Sabarang Fashions Ltd. (9709)

Plot – 85, 86, Block – K, Rupnagar I/A., Section 2, Mirpur, Dhaka-1216

18.AUGUST.2014

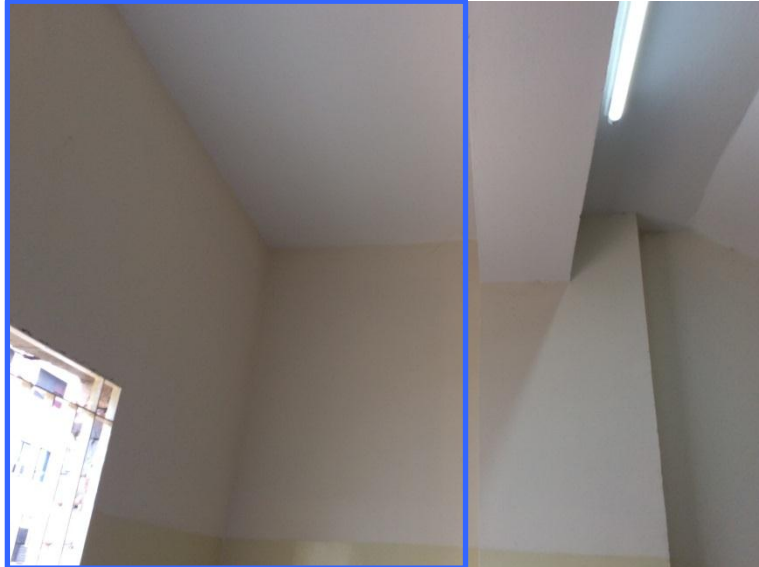
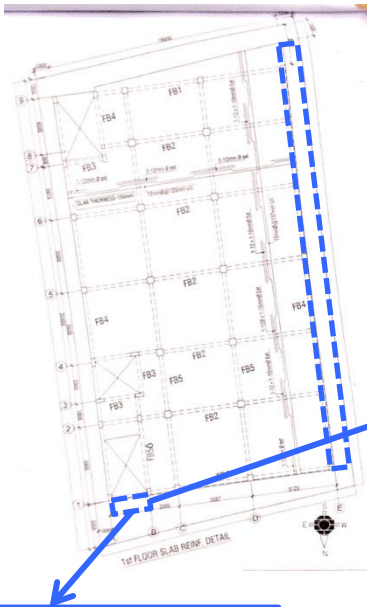
There are cantilevered slabs noted in area shown on the pictures. These do not match the structural drawings.

Floor plans and slab details need to be revised.

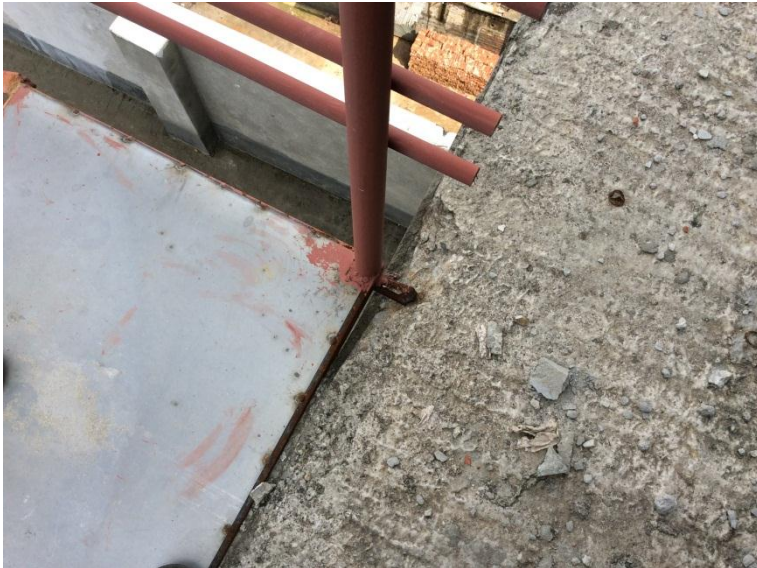
There are cantilevered slabs noted in area shown on the pictures. These do not match the structural drawings.

Concerns on stability and capacity of the steel stair at top level. This should be investigated and strengthened or replaced.

Floor plans and slab details need to be revised.
